2023 ROADWAY IMPROVEMENT PROJECT Duston Road Reconstruction SALEM, NH

ADDENDUM No. 1

January 23, 2023

TOWN OF SALEM
SALEM, NEW HAMPSHIRE
2023 ROADWAY IMPROVEMENT
PROJECT DUSTON ROAD
CIVIL DETAILS (SHEET 6 OF 7)

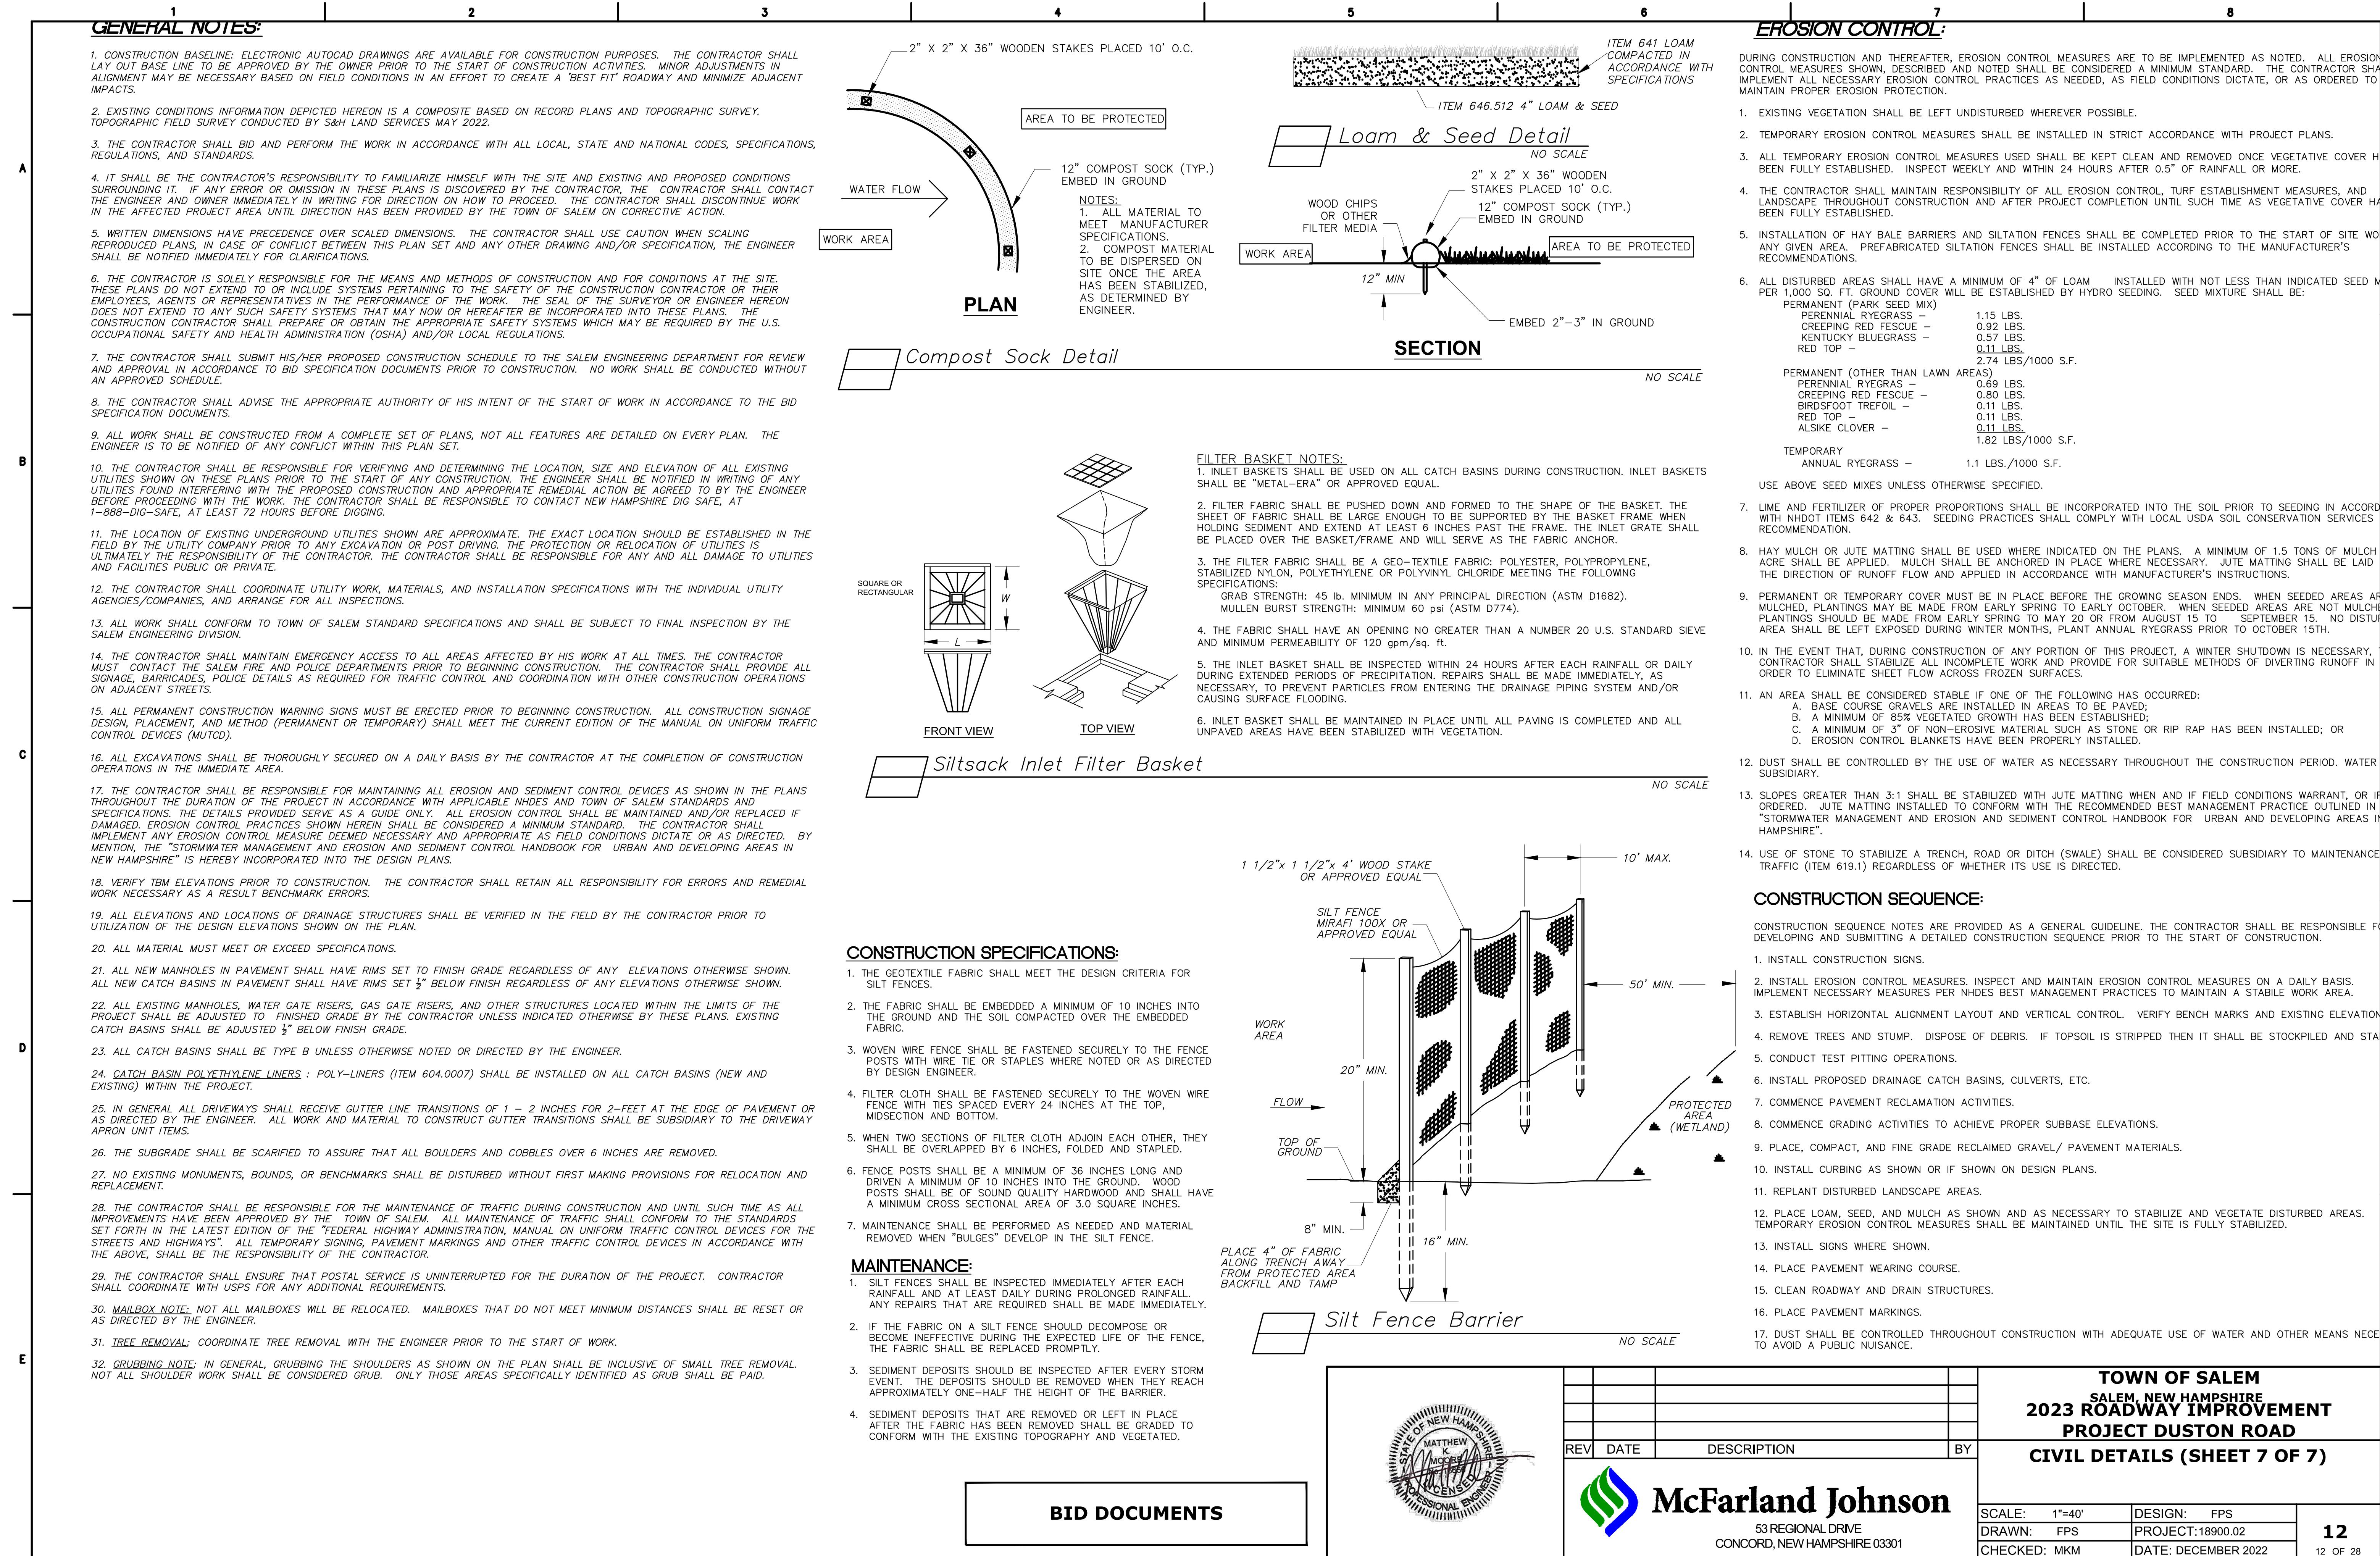
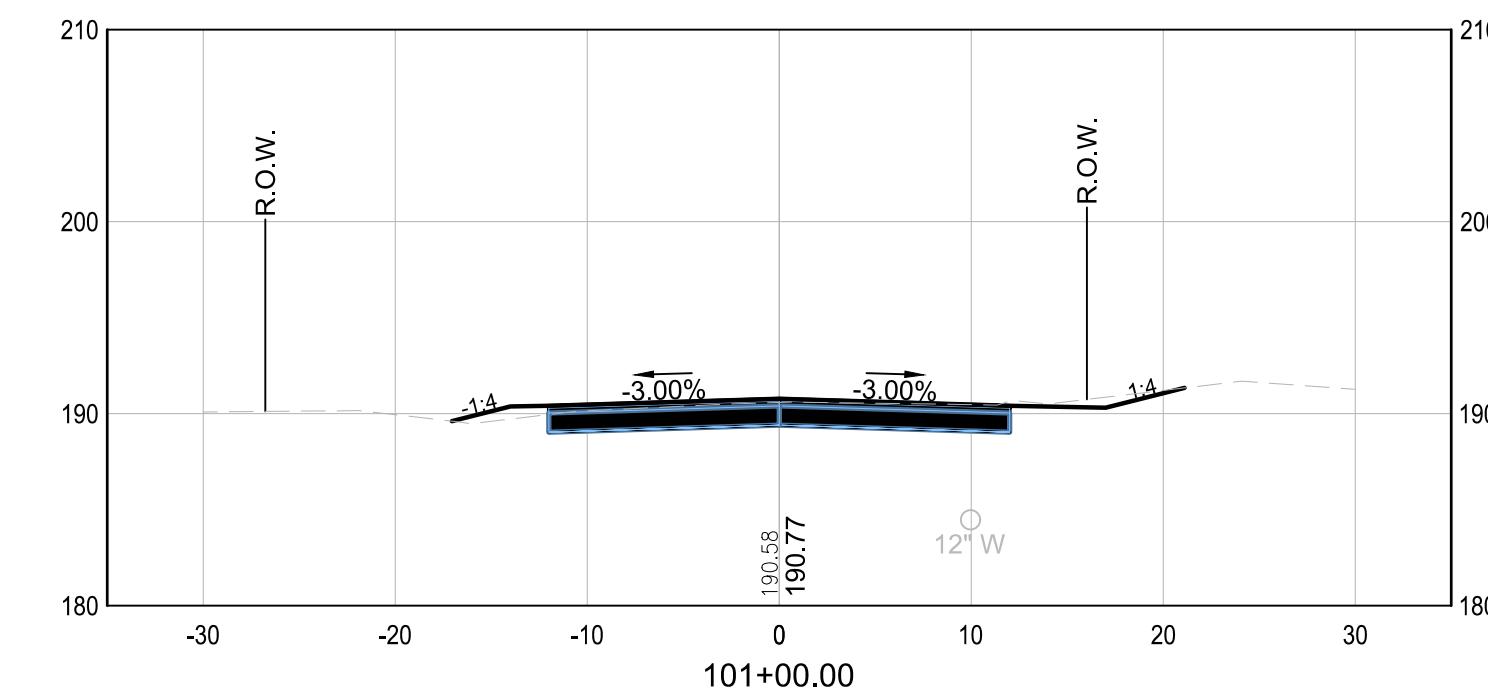
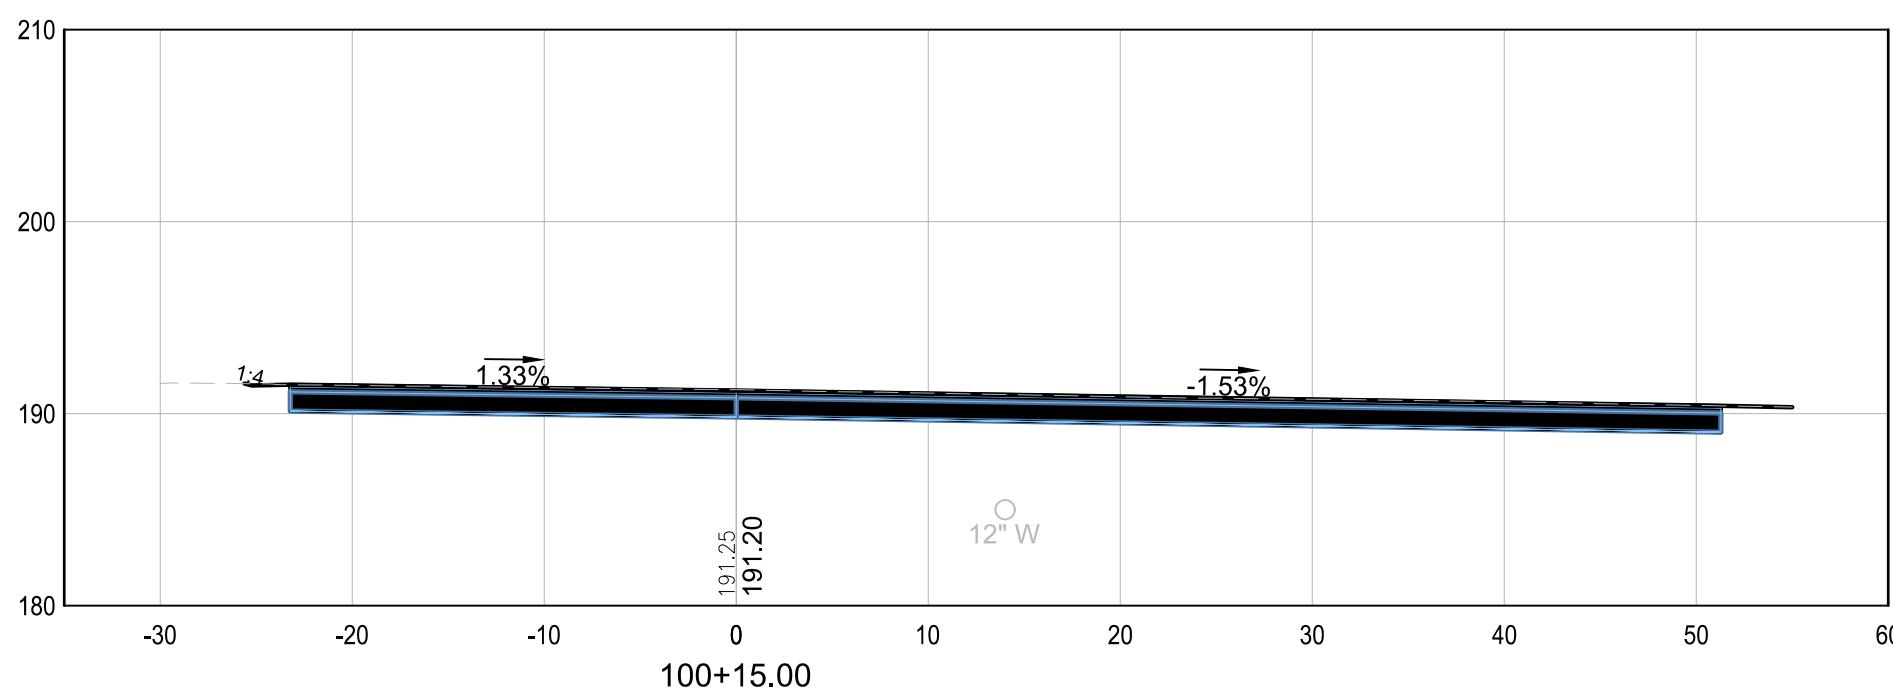
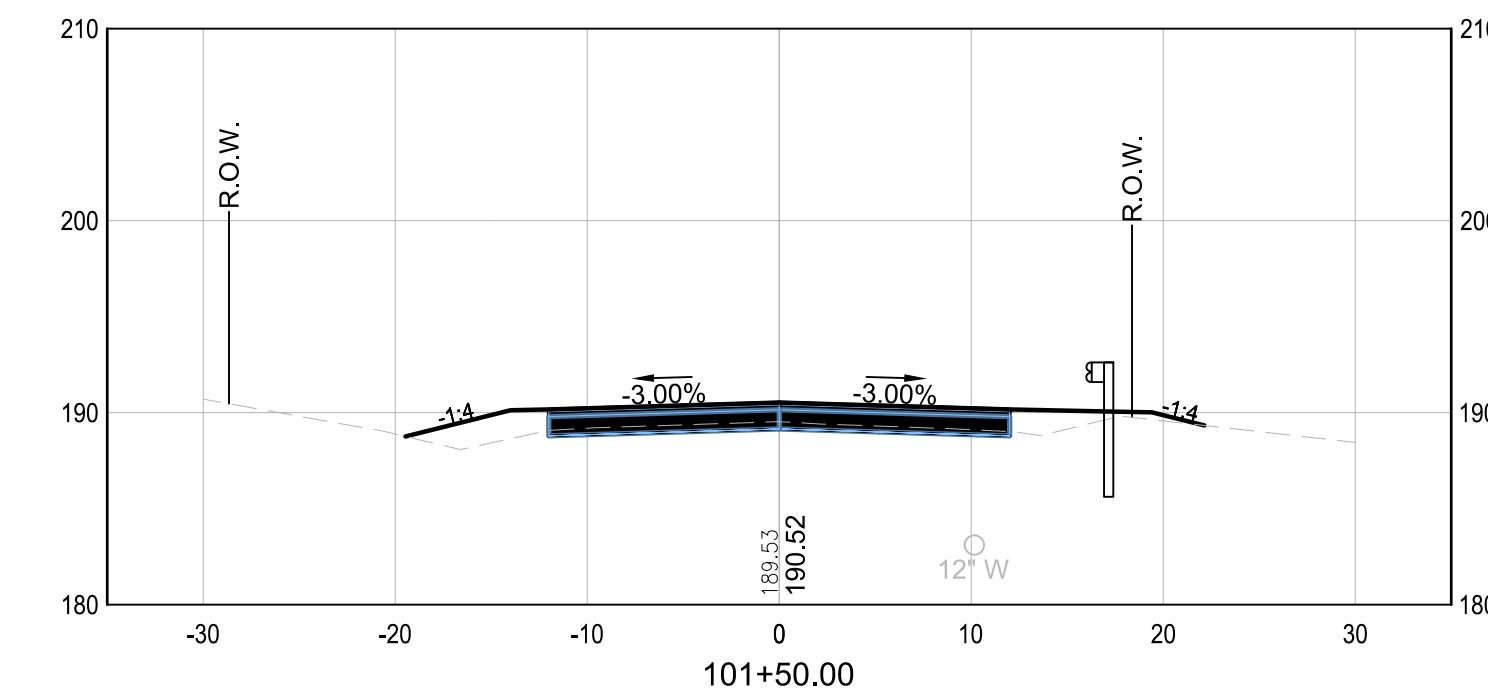
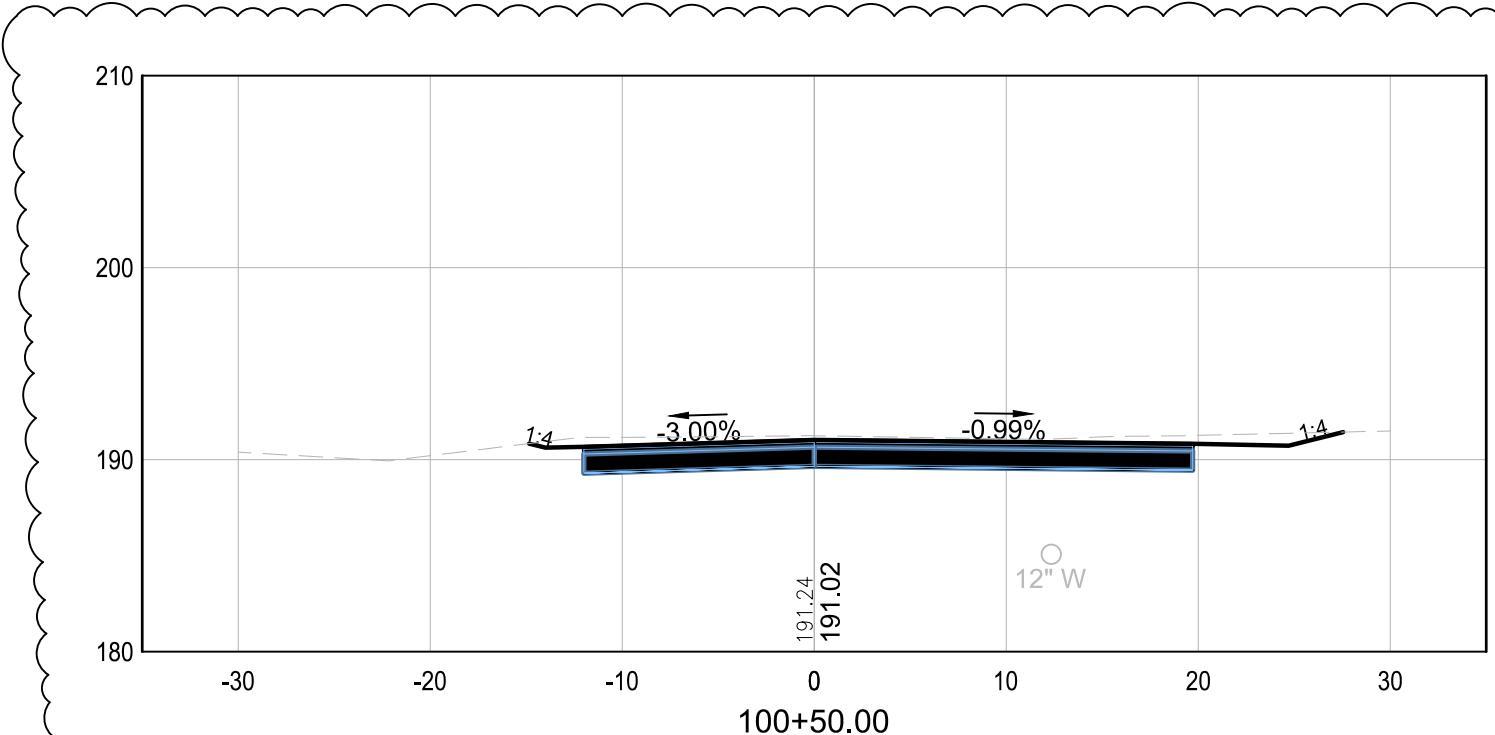
3. No Item for Item 508 Granular backfill. Referenced on sheet 6 note #1 for replacement for ledge removal.

4. No Item for shoulder gravel on the Road (Item 304.32 Shoulder Gravel). Note #2 on Sheet 6 states reclaim level with Binder, does NOT mention shoulder gravel and typical only show loam to EOP.

A clarification note has been added to the typical section on Sheet 6. Where excess reclaim is available at the project site it will be used and paid as embankment (Item 203.6). Where excess reclaim is not available the Contractor will utilize crushed stone fine (Item 304.4).

The typical detail shows loam to the EOP on top of the binder flush reclaim which is correct. The contract provides for loam and seed to the edge of pavement in non-curbed sections of road. Note #2 has been modified to change the intent. In areas that are not front lawn areas or curbed then a 2-foot gravel shoulder shall be provided. It is the intent of the plan to utilize the reclaim windrow to backup the edge of pavement after the binder pavement is placed. The operation will be subsidiary to the reclaim and grading operations. If there is not sufficient windrow available, then excess reclaim shall be utilized and paid as embankment (Item 203.6). If there is not sufficient excess reclaim available, then the contractor shall place crushed stone fine (Item 304.4).
